SM 0134-07
VAR

**STATE OF MARYLAND
CRITICAL AREA COMMISSION
CHESAPEAKE AND ATLANTIC COASTAL BAYS**

Re: R. Tepel Variance, 24151 Half Pone Point Road
Local Case Number 06-2674

DATE: April 12, 2007
TO: Denis Canavan, Director
FROM: Yvonne Chaillet, Zoning Administrator
SUBJECT: AD VAAP #06-2674, Tepel
Administrative Hearing of April 12, 2007
Supplemental Report

Critical Area Site Plan
Tax Map 27, Grid 6, Parcel 49
P/O Half Pine Point
per E.W.A. 267B, Folio 2
Sixth Election District
St. Mary's County, Maryland

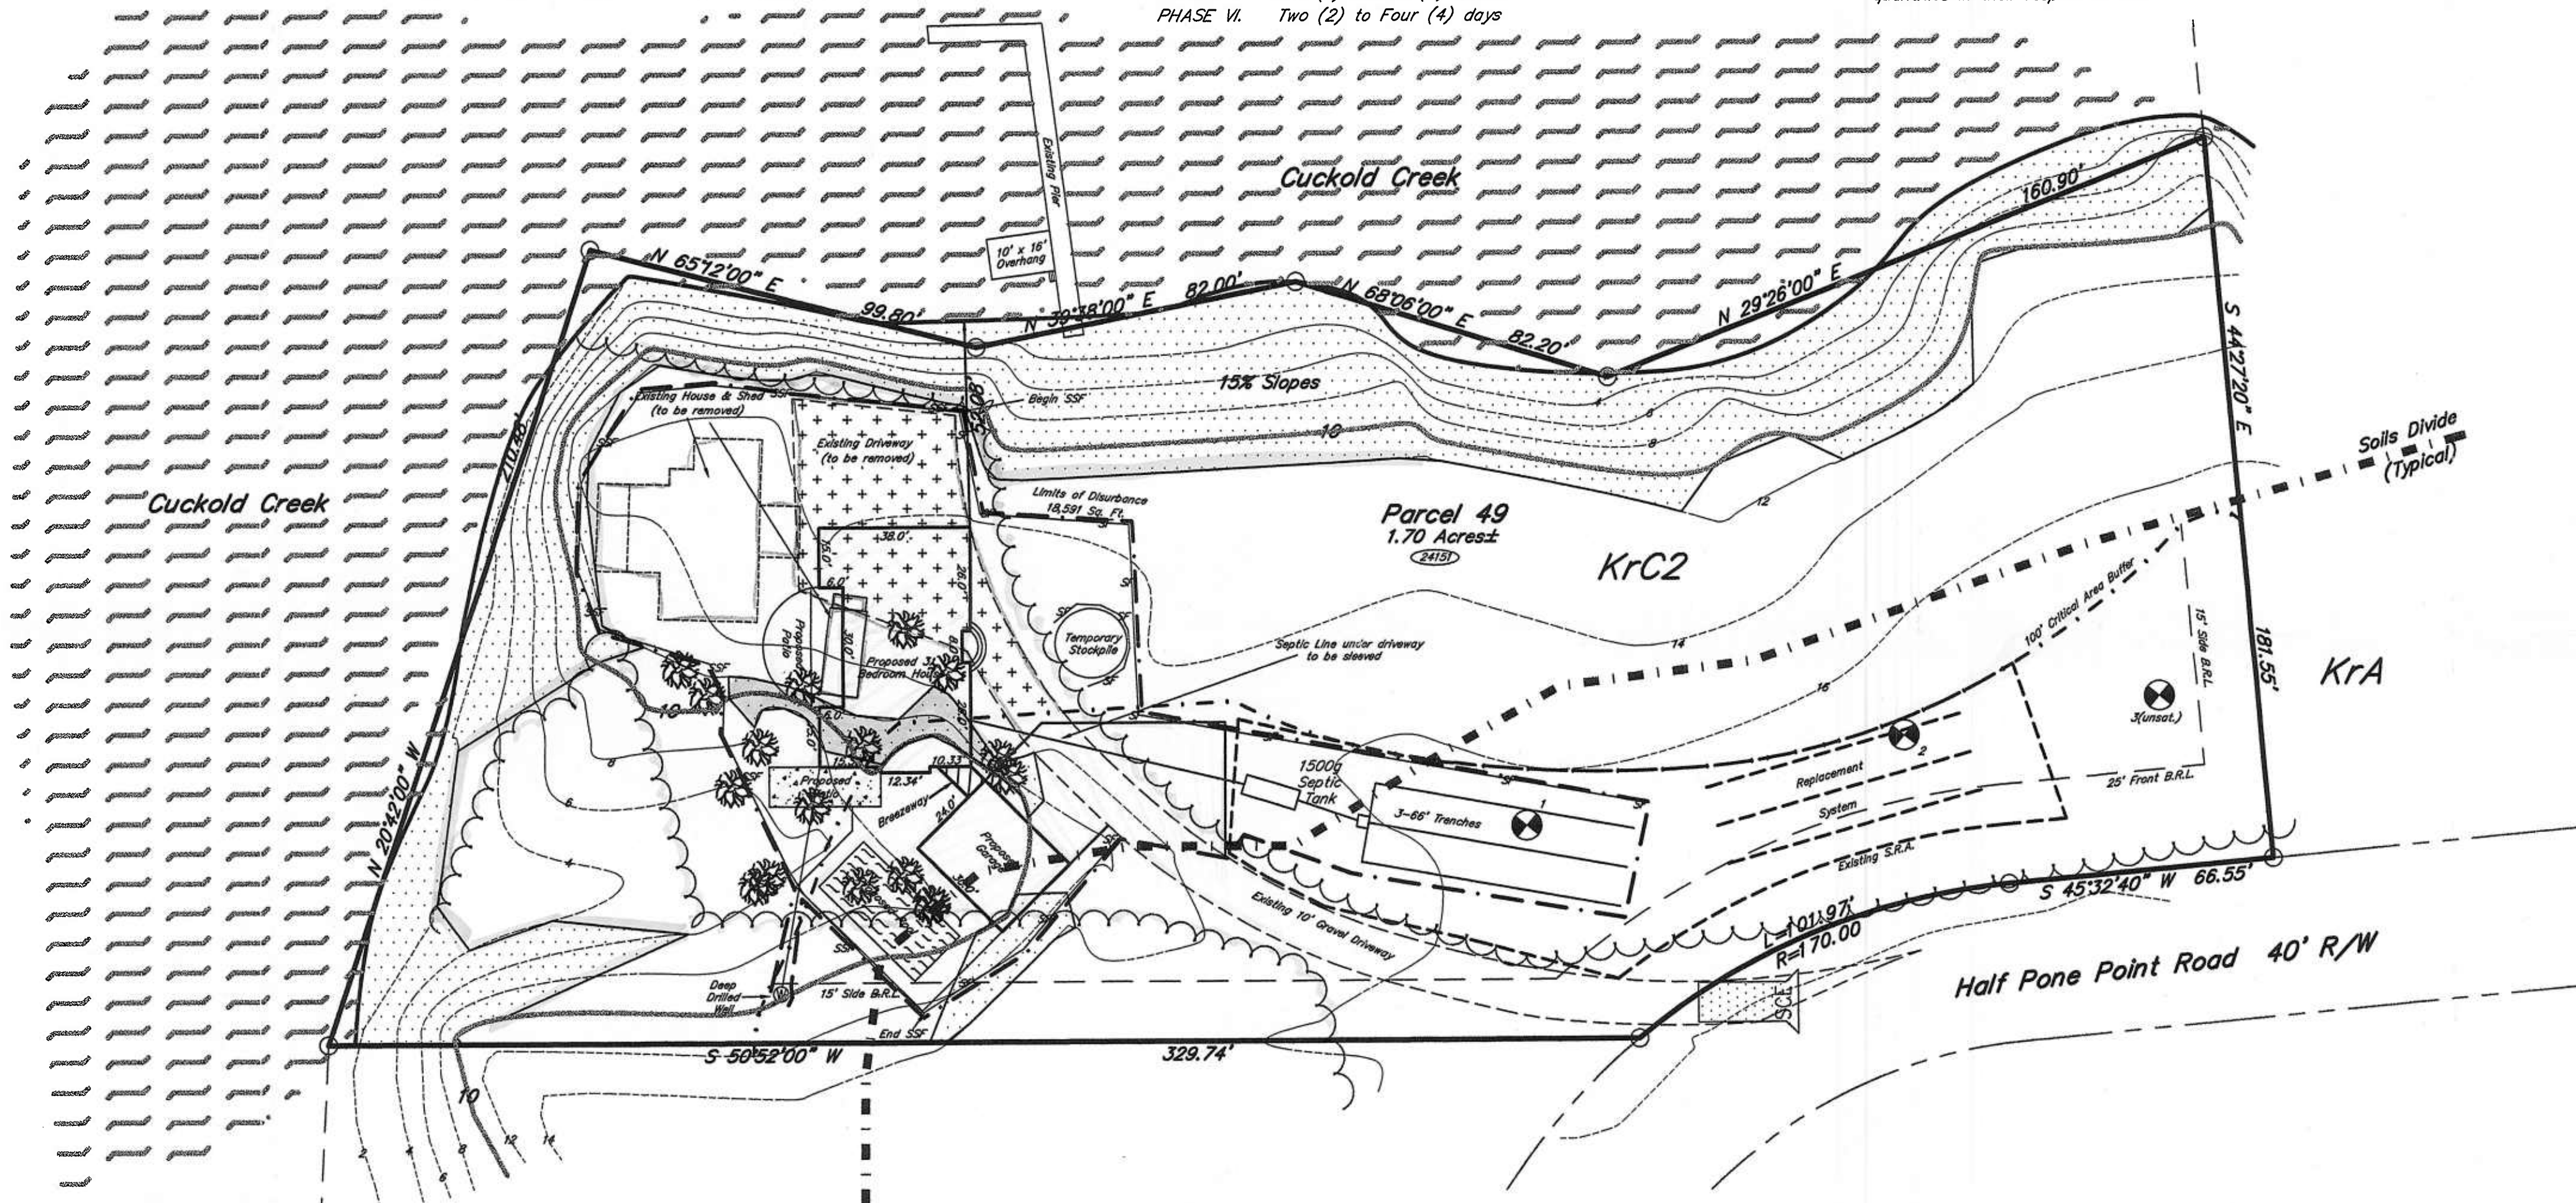
Provided this lot is properly grandfathered, this office does not oppose these variance requests. However, the variances requested must be the minimum necessary. While, the new dwelling is located further inland and is reducing impervious surface within the 100-foot Buffer, it appears the second patio located on the south side of the house is not necessary to establish a residential use and could be located outside of the Buffer. Therefore, while this office concedes the new dwelling may meet the variance standards, the second patio may not.

1. Per CZO Section 41.5.3.i(3)(b), all areas where impervious surface was removed within the 100-foot Buffer should be planted in natural forest vegetation, and mitigation at a ratio of 2:1,

2. A Buffer Management Plan in accordance with Section 71.8.3 should be provided.

4. The Applicants can comply with all of the requirements specified in the above Section, except the limitation of 1,000 square feet placed on the amount of impervious surface that can be traded in the Buffer.
5. The Applicants are proposing to construct two patios: one on the back or waterside of the house and one on the southeast corner of the Property. Staff cannot support locating a patio on the southeast corner of the Property because it is in steep slopes and prohibited by Section 71.7 of the Ordinance. It is also in the Buffer and cannot meet the minimum necessary standard for granting a variance.

1. The Applicants shall remove the patio proposed in the southeast corner of the Property; and
2. The Applicants shall adhere to the requirements of the Critical Area Planting Agreement (CAPA #06-2674) which requires mitigation at a ratio of three to one (3:1) per square foot of the variances granted pursuant to Section 24.4.2.b of the Ordinance.

Ms. Greb submitted copies of a revised site plan showing that the patio in the southeast corner of the Property had been removed. Ms. Greb had received the staff report in advance, which indicated that staff and the Critical Area Commission did not support the impervious surface in the Buffer from this patio.
